June 14, 1983

Subject: Limerick Generating Station, Units 1 & 2  
Request for Additional Information (RAI)  
from NRC Materials Engineering  
Branch, Materials Application Section

Enclosed, in response to the reference letter, are draft responses to RAI's 252.1 through 252.7 and related draft FSAR text changes.

# Figure 5.3-4 Limerick Unit 1

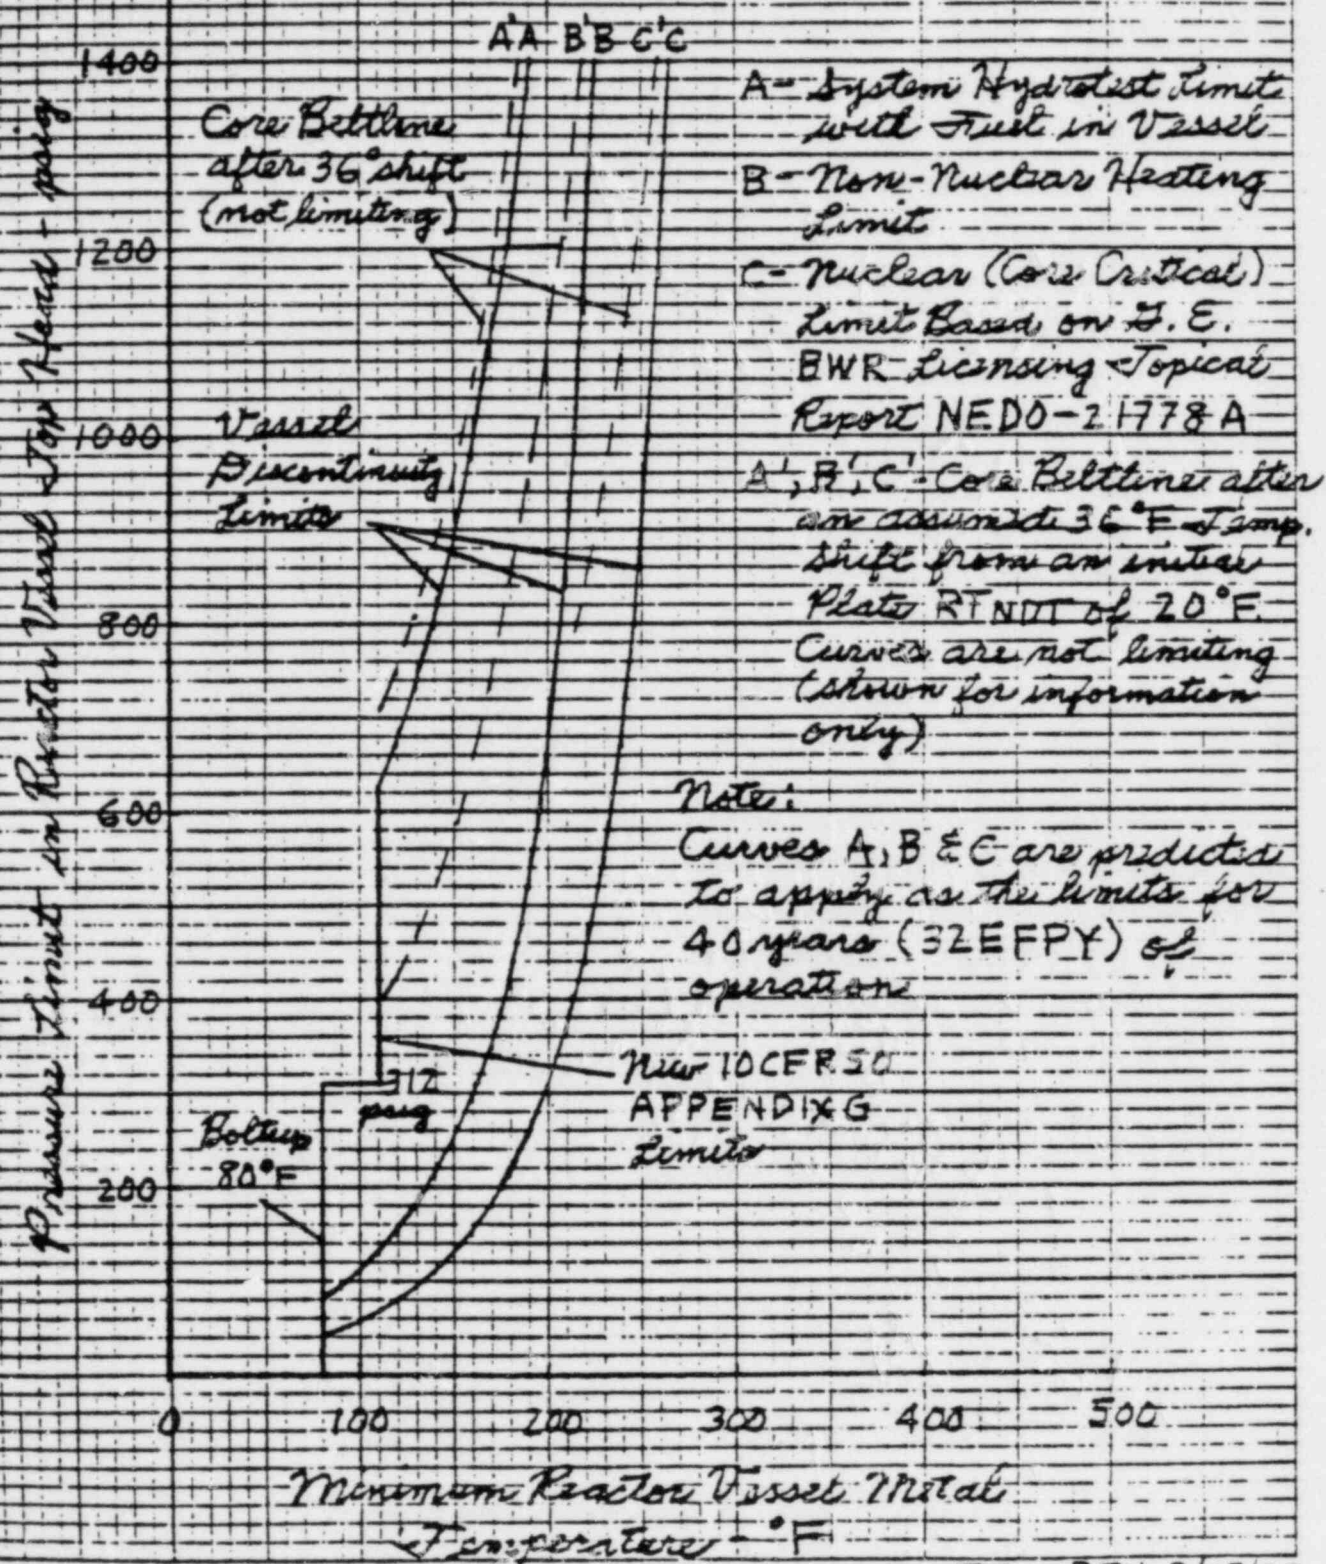
- a. indicate all flange and shell regions near geometric discontinuities that, during vessel operation, will not provide margins of safety in accordance with Appendix G, Section III of the ASME Code,
- b. for all locations in Item a, estimate the critical crack size during normal operation which provides a margin of safety equivalent to Appendix G, Section III of the ASME Code. Indicate the method of analysis,
- c. indicate which non-destructive test methods can be performed during in-service inspection to examine for cracks of the size and location identified in Item a and b.

- a. The effect of the main closure flange discontinuity is considered by adding 60°F and 90°F to the  $RT_{NDT}$  to establish the minimum temperature for bolt-up and pressurization, respectively, as shown in Figure 5.3-4. The minimum bolt-up temperature of 80°F for Limerick Unit 1, which is shown in Figure 5.3-4, is based on an initial  $RT_{NDT}$  of +20°F for the shell plate which connects to the closure flange. The minimum bolt-up temperature of +70°F for Limerick Unit 2, which is shown in Figure 5.3-5 is based on an initial  $RT_{NDT}$  of +10°F for the closure flange forgings.

The effect of the main closure flange discontinuity is considered by adding 60°F and 90°F to the  $RT_{NDT}$  to establish the minimum temperature for boltup and pressurization respectively. The minimum boltup temperature of 80°F for Limerick Unit 1, which is

shown in Figure 5.3-4 is based on an initial  $RT_{NDT}$  of  $+20^{\circ}F$  for the shell plate which connects to the closure flange. The minimum boltup temperature of  $+70^{\circ}F$  (preliminary) for Limerick Unit 2, which is shown in Figure 5.3-5, is based on an initial  $RT_{NDT}$  of  $+10^{\circ}F$  for the closure flange forgings.
